Economic Commission for Europe

Convention on Road Signs and Signals (1968)

Proposal for amendments to Annexes 1 and 3

Submitted by the Chair of the Group of Experts on Road Signs and Signals and the secretariat

**DOUBLE BEND OR SUCCESSION OF MORE THAN TWO BENDS, THE FIRST TO THE RIGHT**

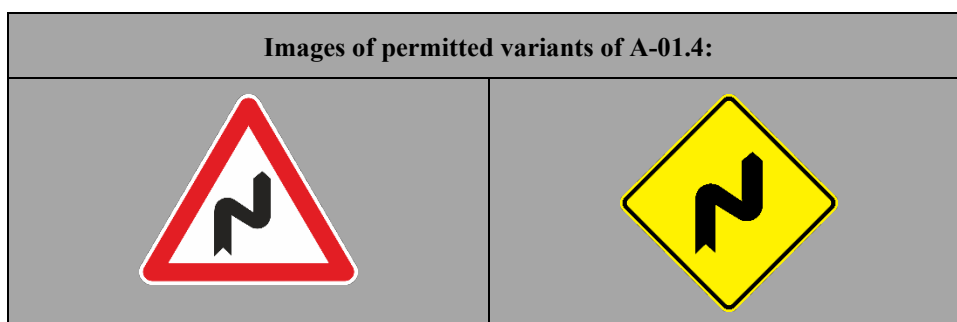
A-01.4 gives warning of a dangerous double bend, or a succession of more than two bends, the first to the right.

DANGEROUS DESCENT

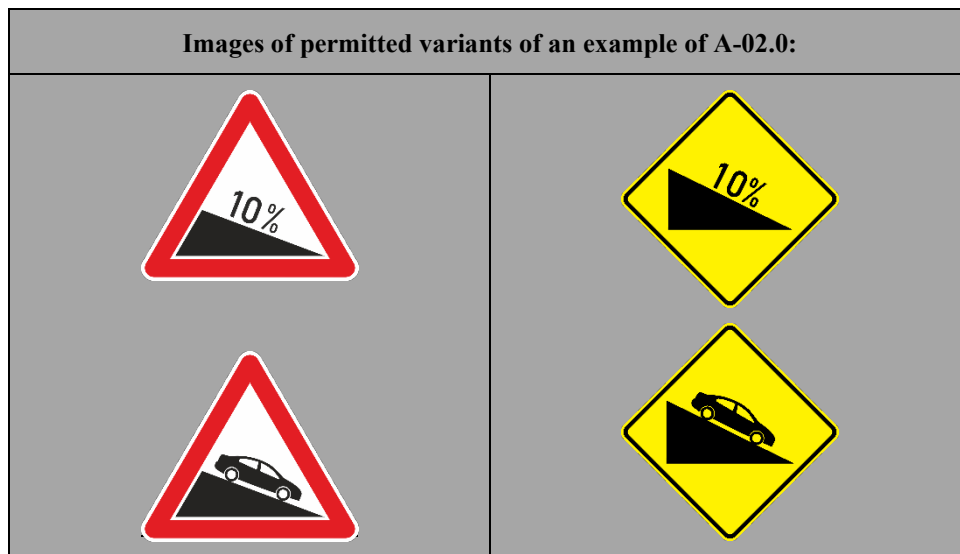
(a) To give warning of a steep descent symbol A, 2a shall be used with the sign of model Aa, or symbol A, 2b with the sign of model Ab.

(b) The left hand part of symbol A, 2a shall occupy the left hand corner of the sign panel and its base shall extend over the whole width of the panel. The figure in symbols A, 2a and A, 2b shows the gradient as a percentage; it may be replaced by a ratio (1:10). It shall, however, be open to Contracting Parties taking into account as far as possible the provisions of Article 5, paragraph 2 (b) of this Convention, to use, instead of symbol A, 2a or A, 2b, symbol A, 2c if they have adopted the sign of model Aa and symbol A, 2d if they have adopted the sign of model Ab.

A-02.0 gives warning of a dangerous descent. The symbol of a car or a percentage or both, may be used. An arrow in the ground colour of the sign may be embedded into the black triangular part of the symbol when the percentage symbol is used.

STEEP ASCENT

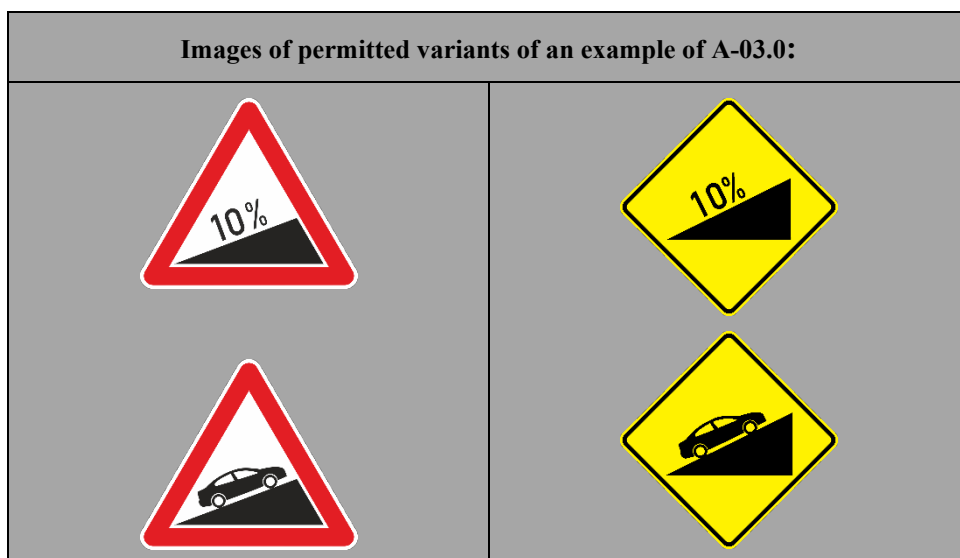
(a) To give warning of a steep ascent, symbol A, 3a shall be used with the sign of model Aa, or symbol A, 3b with the sign of model Ab.

(b) The right hand part of symbol A, 3a shall occupy the right hand corner of the sign panel and its base shall extend over the whole width of the panel. The figure in symbols A, 3a and A, 3b shows the gradient as a percentage; it may be replaced by a ratio (1:10). It shall, however, be open to Contracting Parties which have chosen symbol A, 2c as the symbol for a dangerous descent to use symbol A, 3c instead of A, 3a, and to Contracting Parties which have chosen symbol A, 2d to use symbol A, 3d instead of A, 3b.

A-03.0 gives warning of a steep ascent. The symbol of a car or a percentage or both, may be used. An arrow in the ground colour of the sign may be embedded into the black triangular part of the symbol when the percentage symbol is used.

**CARRIAGEWAY NARROWS LEFT**

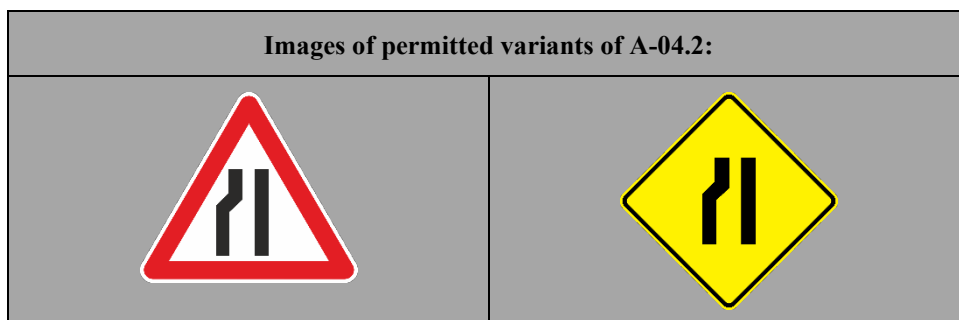
A-04.2 gives warning that the carriageway ahead is narrower on the left-hand side. This sign shall not be used for indicating a reduction in the number of lanes.

**CARRIAGEWAY NARROWS RIGHT**

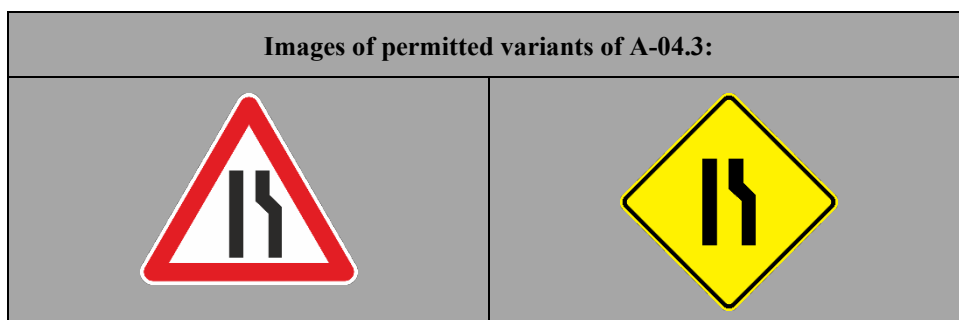
A-04.3 gives warning that the carriageway ahead is narrower on the right-hand side. This sign shall not be used for indicating a reduction in the number of lanes.

LOOSE GRAVEL

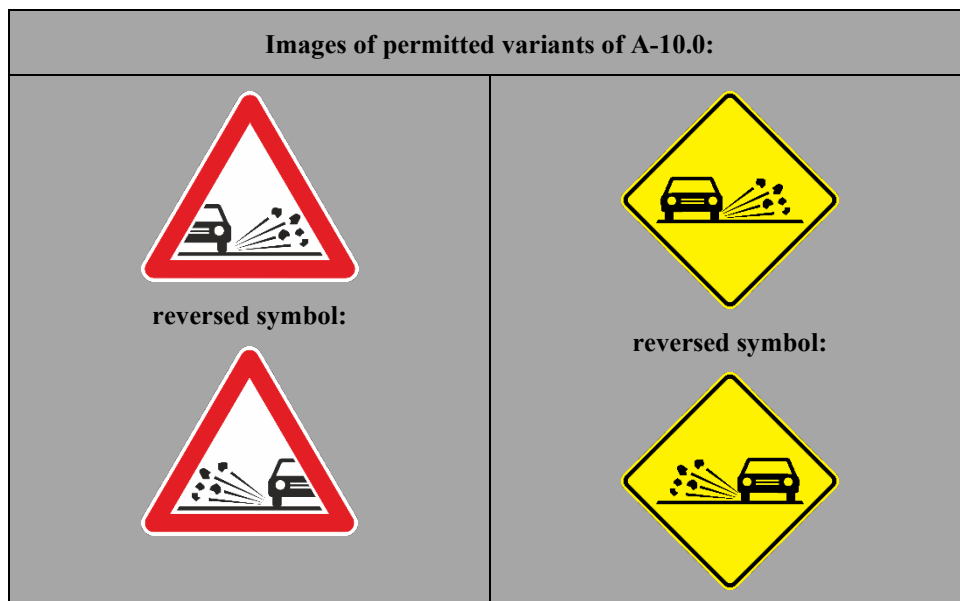
~~Warning of a section of road on which gravel may be thrown up shall be given by symbol A, 10a used with the sign of model Aa or by symbol A, 10b with the sign of model Ab.~~

A-10.0 gives warning of a section of road on which gravel may be thrown up. The symbol on this sign may be reversed.

FALLING ROCKS

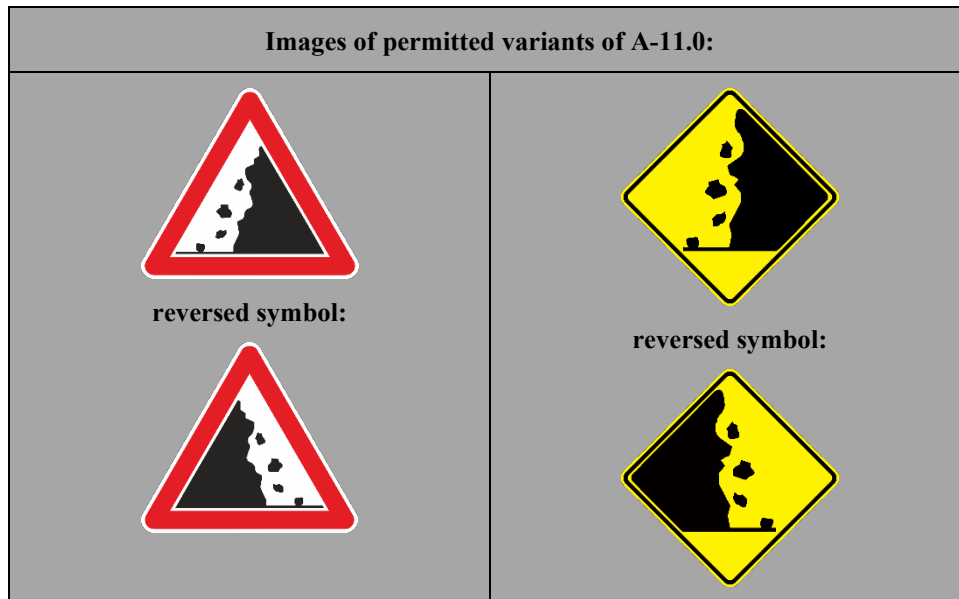
~~(a) Warning of a section of road on which there is danger from falling rocks and the consequent presence of rocks on the carriageway shall be given by symbol A, 11a used with the sign of model Aa or by symbol A, 11b with the sign of model Ab.~~

~~(b) The right hand part of the symbol shall occupy the right hand corner of the sign panel in both cases.~~

~~(c) The symbol may be reversed.~~

A-11.0 gives warning of a section of road on which there is danger from falling rocks and the consequent presence of rocks on the carriageway. The symbol on this sign may be reversed.

PEDESTRIANS

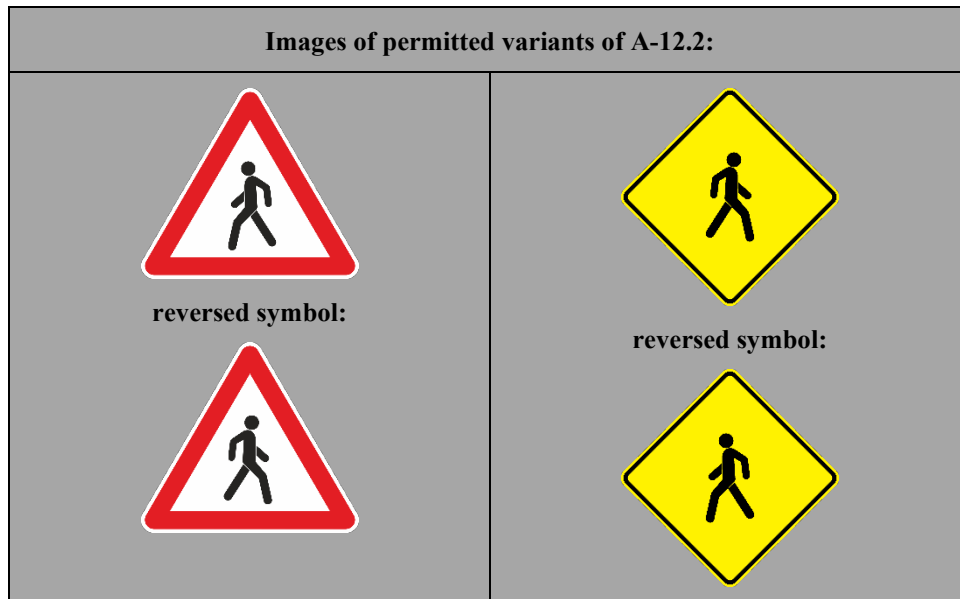
A-12.2 gives warning of a section of road frequented by pedestrians. The symbol on this sign may be reversed.

CHILDREN

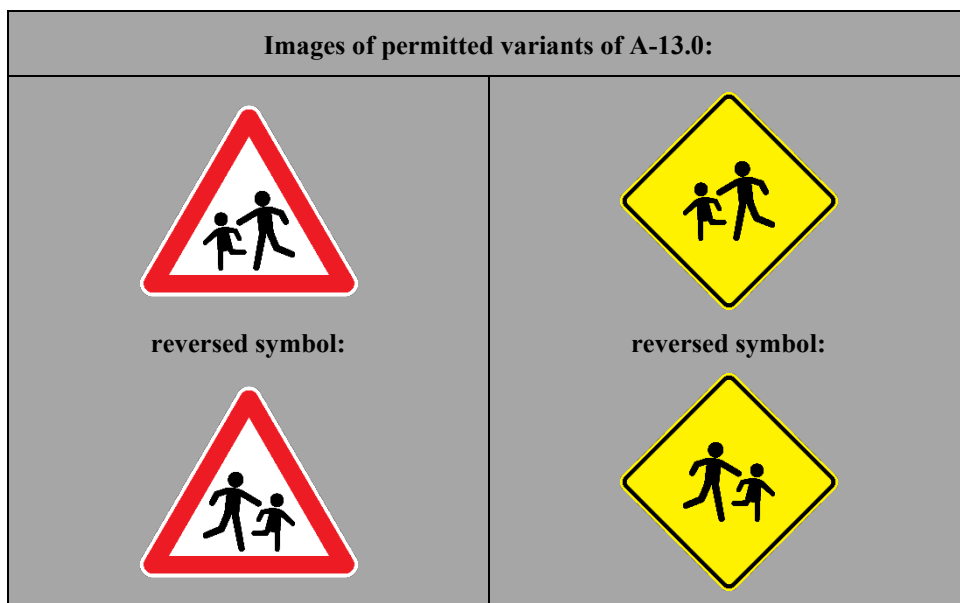
~~(a) Warning of a section of road frequented by children, such as the exit from a school or playground shall be given by symbol A, 13.~~

~~(b) The symbol may be reversed.~~

A-13.0 gives warning of a section of road frequented by children, such as in proximity of a school or playground. The symbol on this sign may be reversed.

CYCLISTS ENTERING OR CROSSING

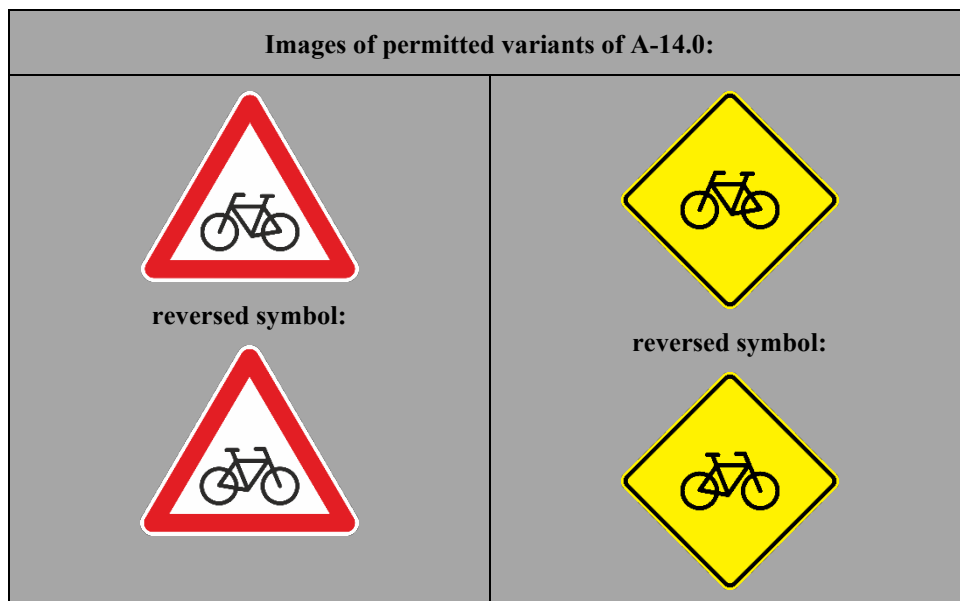
~~(a) Warning of a point at which cyclists frequently enter or cross the road shall be given by symbol A, 14.~~

A-14.0 gives warning of a point at which cyclists frequently enter or cross the road. The symbol on this sign may be reversed.

DOMESTIC ANIMALS CROSSING

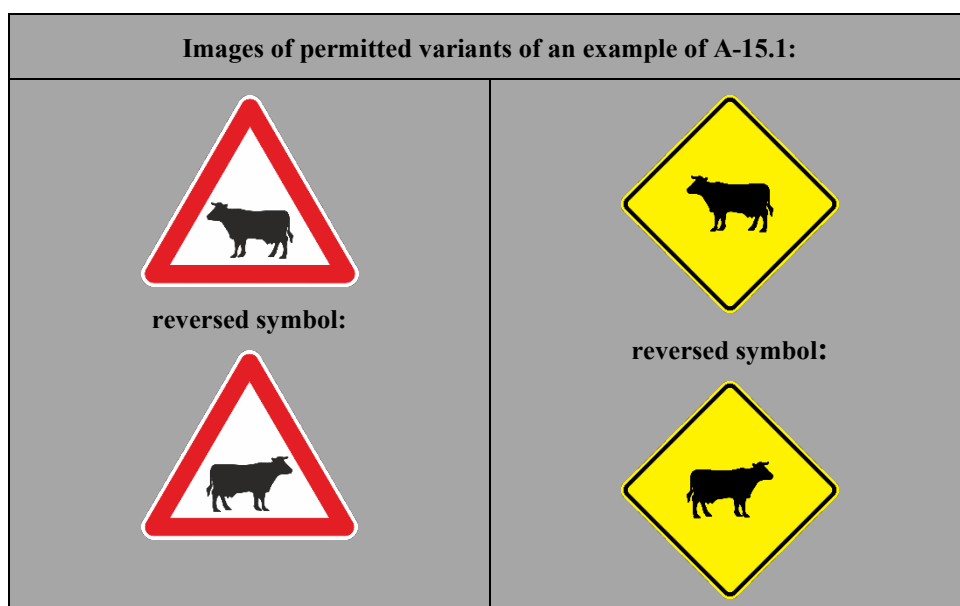
(a) ~~Warning of a section of road on which there is a particular danger of animals crossing shall be given by a symbol representing the silhouette of the animal, domestic or wild, most frequently encountered, such as symbol A, 15a for a domestic animal and symbol A, 15b for a wild animal.~~

A-15.1 gives warning of a section of road on which there is a particular danger of domestic animals crossing. The symbol shall represent the silhouette of the domestic animal most frequently encountered. The symbol on this sign may be reversed.

WILD ANIMALS CROSSING

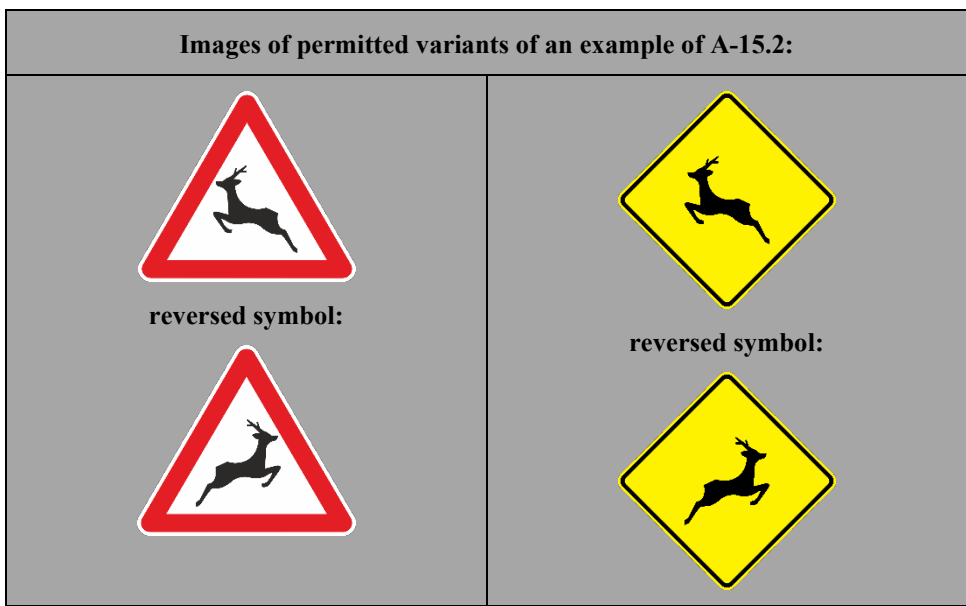
A-15.2 gives warning of a section of road on which there is a particular danger of wild animals crossing. The symbol shall represent the silhouette of the wild animal most frequently encountered. The symbol on this sign may be reversed.

ROAD WORKS

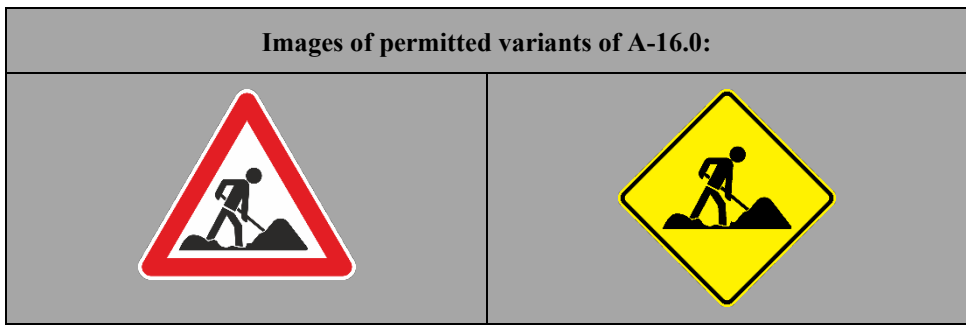
~~Warning that work is in progress on the section of the road ahead shall be given by symbol A, 16.~~

A-16.0 gives warning that work is in progress on the section of the road ahead.

TRAFFIC LIGHT SIGNALS

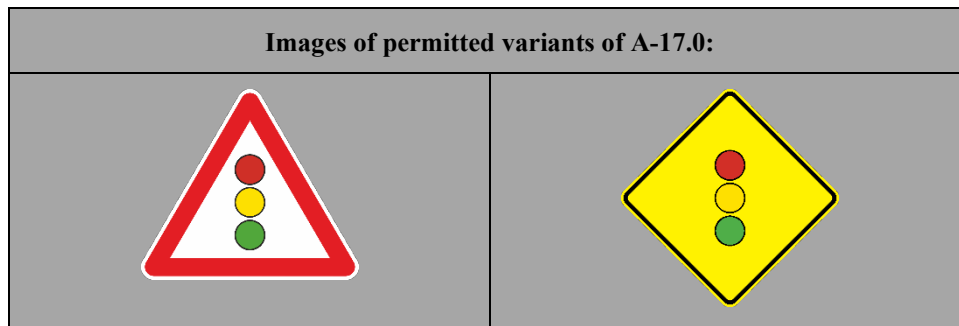
~~(a) If it is considered essential to give warning of a section of road on which traffic is regulated by three colour light signals, because road users would not expect such a section, symbol A, 17 shall be used. There are three models of symbol A, 17: A, 17a ; A, 17b ; and A, 17c , which correspond to the arrangements of lights in the three colour system described in Article 23, paragraphs 4 to 6 of this Convention.~~

~~(b) This symbol shall be in the three colours of the lights of which it gives warning.~~

A-17.0 gives warning of a section of road on which traffic is regulated by three-colour traffic light signals. The symbol shall be in the three colours of the traffic lights of which it gives warning. These three colours shall be surrounded by a dark colour narrow strip.

This sign shall only be used on road sections on which road users would not expect traffic light signals.

This sign may supplement or replace the signs A-18.1, A-18.2, A-19.1, A-19.2, and a-20.0 if traffic at the intersection is regulated by a traffic light signal.

INTERSECTION WITH GENERAL PRIORITY RULE

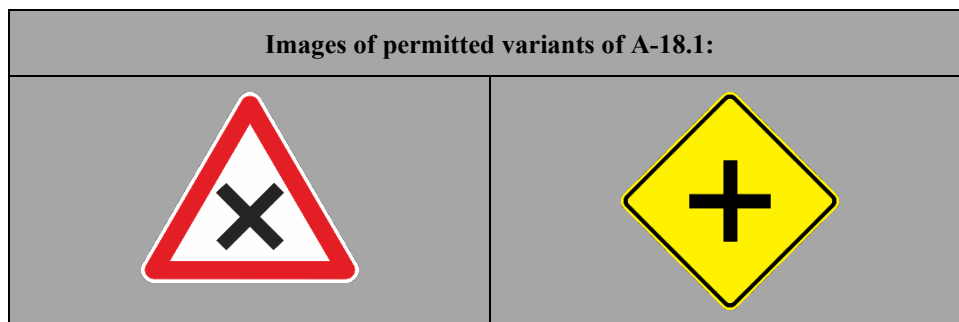
~~(a) Warning of an intersection where the priority is that prescribed by the general priority rule in force in the country shall be given by symbol A, 18a used with sign Aa or by symbol A, 18b used with sign Ab.~~

A-18.1 gives warning of an intersection where the priority is that prescribed by the general priority rule in force in the country.

STOP

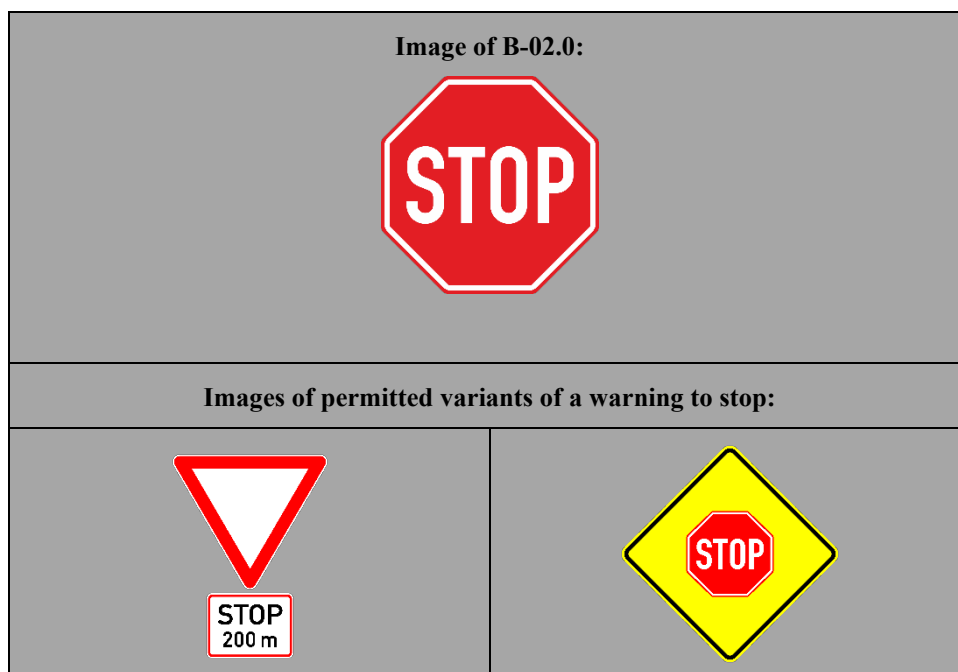
B-02.0 notifies drivers that, at the intersection where the sign is placed, they must stop before entering the intersection and give way to vehicles on the road they are approaching. The sign is an octagon with a red ground surrounded by a white rim and bears the "STOP" inscription in white in English or in the language of the State concerned. The height of the inscription shall not be less than one third of the height of the panel.

**3. Compulsory roundabout****COMPULSORY ROUNDABOUT**

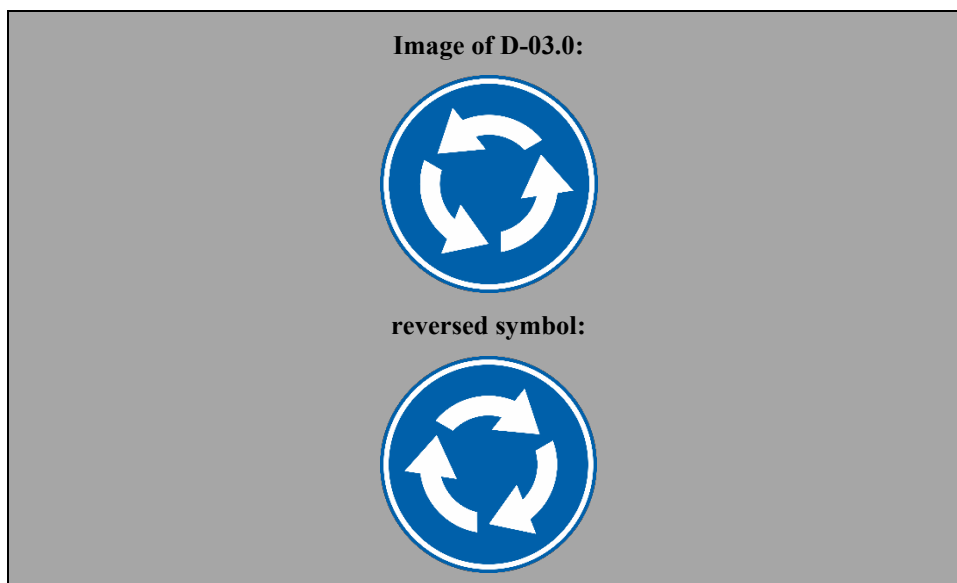
3. Sign D, 3 D-03.0 'COMPULSORY ROUNDABOUT', shall notify that vehicles must follow the direction at the roundabout indicated by the arrows. If the compulsory roundabout is indicated by the sign D, 3 D-03.0 together with the sign B, 1 B-01.0 or B, 2 B-02.0, the driver vehicle in the roundabout has priority. The symbol on this sign shall be reversed for traffic keeping to the left.

END OF TUNNEL

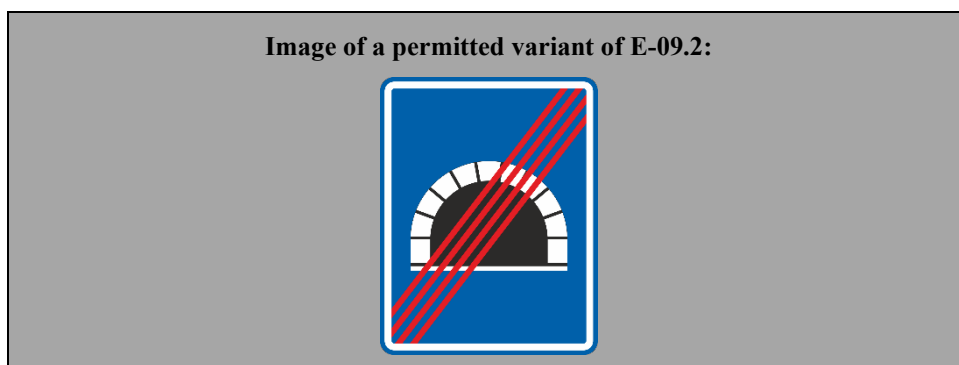
(c) Sign E-11b E-09.2 'END OF TUNNEL' notifies that the special traffic rules imposed by sign E-11a E-09.1 may be placed at the point from which the special rules no longer cease to apply from the point of its placement. This sign shall be identical to E-09.1 except that it shall be crossed by a diagonal red band or, preferably, red parallel lines forming such a band running from the upper right edge to the lower left edge. The diagonal band may be interrupted when crossing the symbol. If not interrupted, the diagonal band shall be placed over the symbol.

BREAKDOWN SERVICE

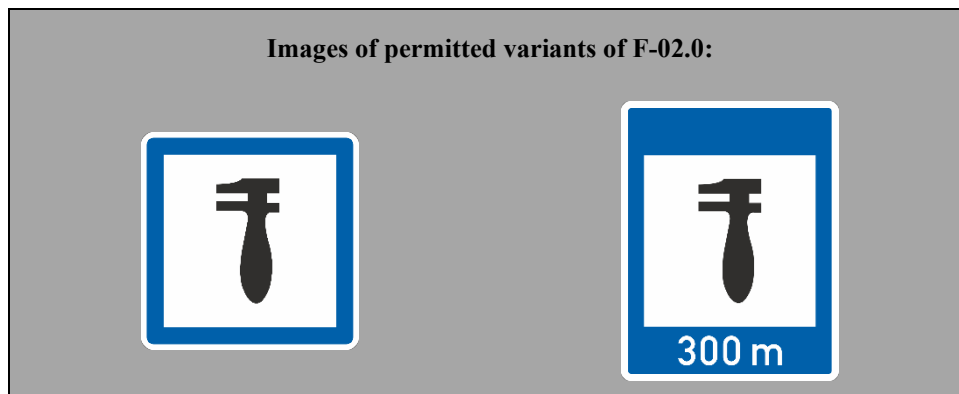
F-02.0 "~~BREAKDOWN SERVICE~~") notifies of a location of a breakdown service.
